# One LLID per ONU!

(Comments to clause 56)

Vincent Bemmell, Alloptic  
Ajung Kim, Samsung  
Bob Gaglianella, Lucent

# Why not multiple LLIDs per physical ONU?

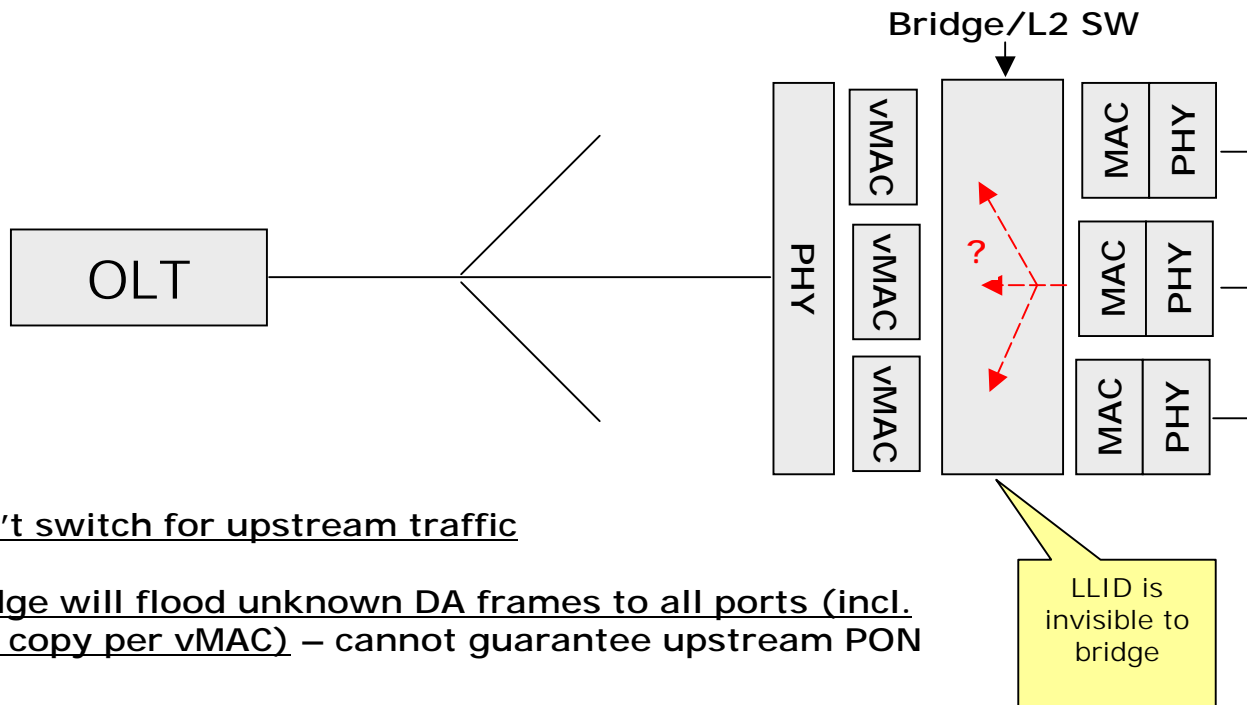
- Because the Multiple LLID/ONU model is simply not viable!
  1. A Multi-port ONU requires a bridge/L2 switch. Without it...
    - Downstream single copy broadcast breaks at ONU MAC
    - Cannot support intra-ONU bridging
    - Complicates standard SLA management (min/max BW + selective discarding)
  2. This bridge only works with a single MAC at the PON port
  3. Severe scalability problems:
    - MPCP granting overhead =  $F\{\#LLIDs * Guardband\}$
  4. No LLID visible above the OLT (no LLID → VLAN / MPLS continuity)
  5. 'Multiple LLIDs per physical ONU' is equivalent to assigning multiple MAC addresses to a single hardware instance
  6. Per-port statistics are readily available with basic switch today

# Multi-LLID Architecture

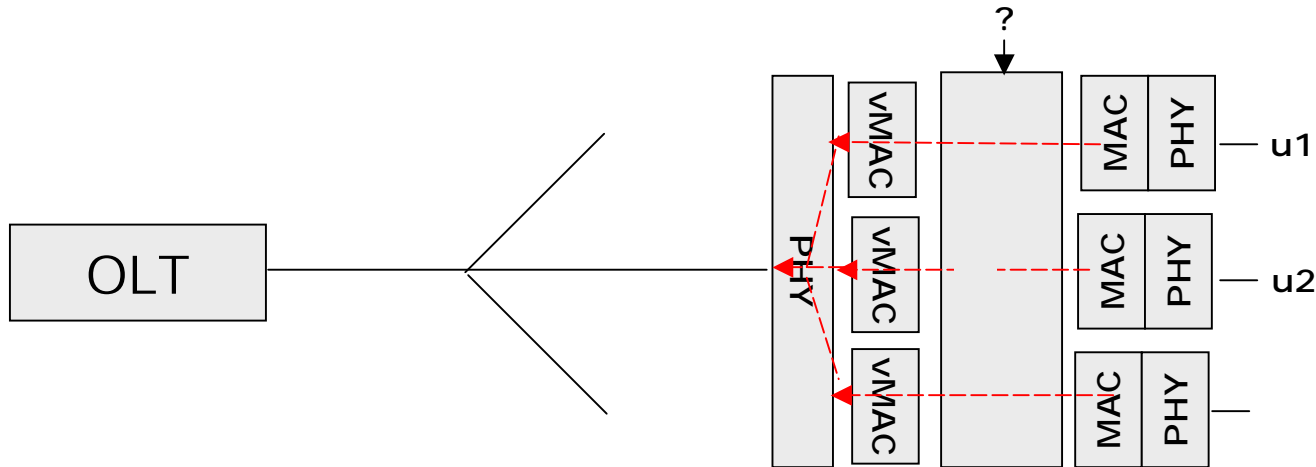
Option 2. No 802.1D bridge... but new 'bridge' in ONU

1. vMACs are 802.3 extensions to support a TBD non-IEEE 'bridge'
2. LLIDs are not visible above the vMACs
3. Model cannot support intra-ONU bridging (u1 to u2)  
→ Requires reflection at OLT bridge (at cost of PON BW)

Not quite a bridge, but... filters/forwards between MAC - based on MAC addresses?

Does not work

# Multi-LLID Architecture & Broadcast

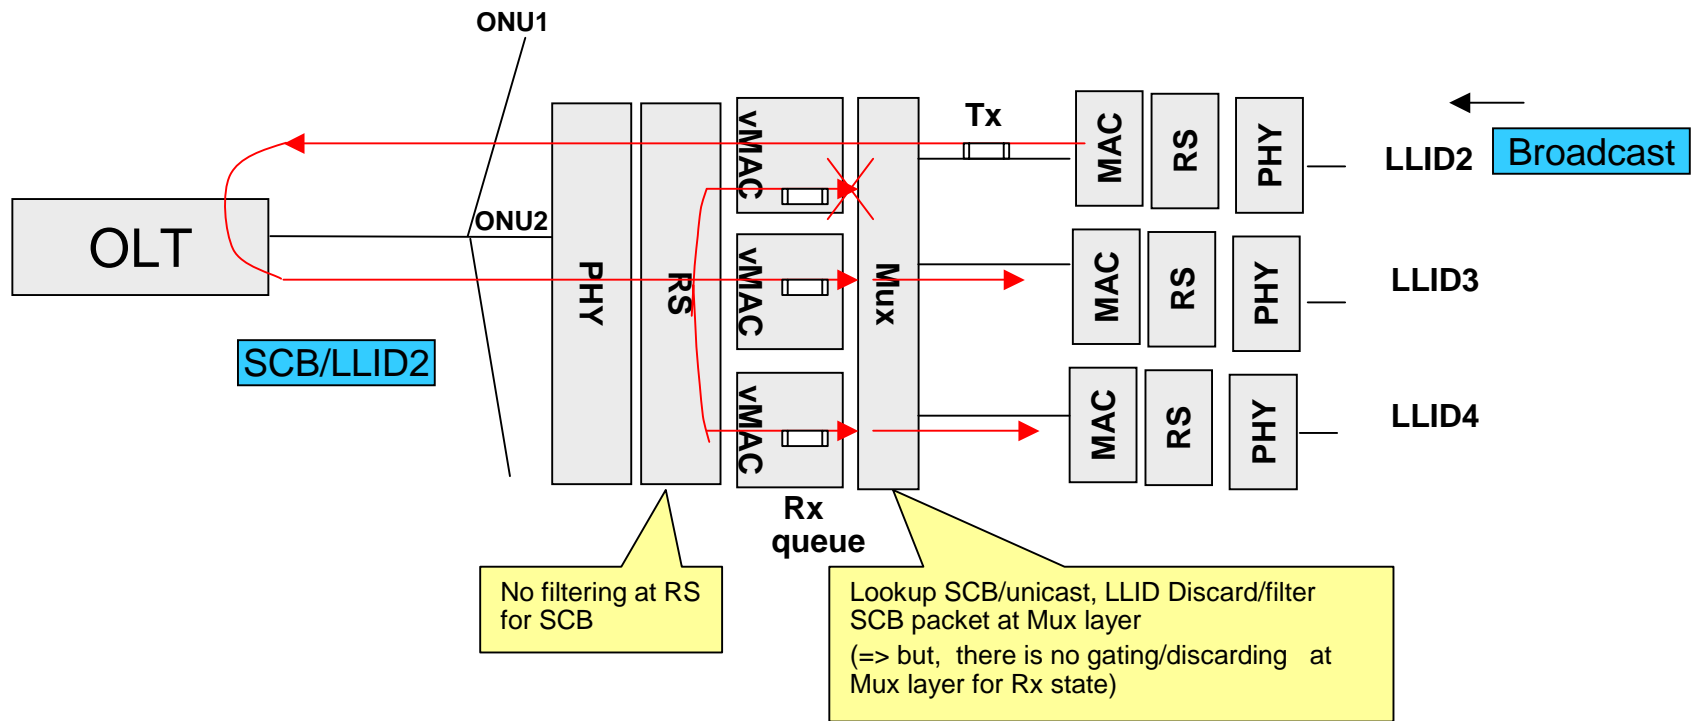
(Option 2. No 802.1D bridge)

Does not work

# Single LLID Architecture

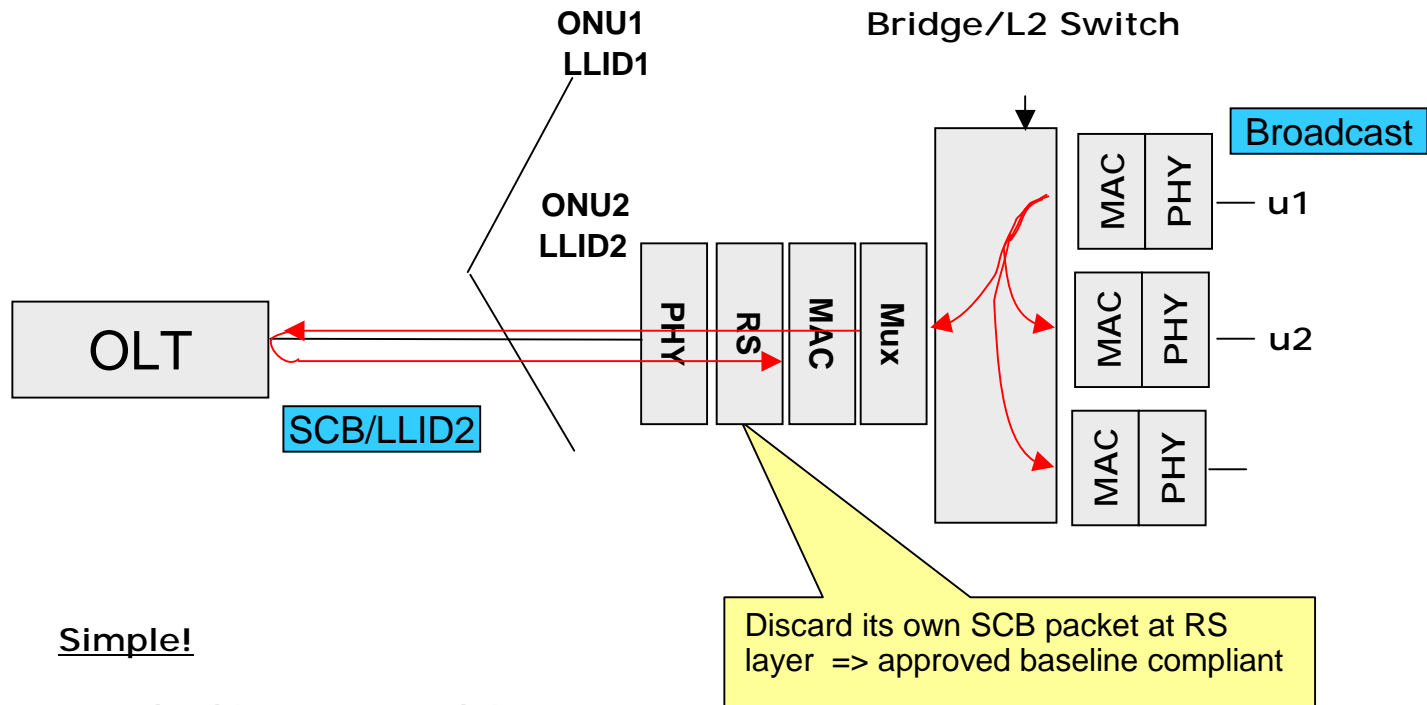
1. Simple!
2. Standard layering model
3. No upstream switching problem
4. supports intra-ONU bridging (u1 to u2)
5. No SCB problem

**Works!!!**
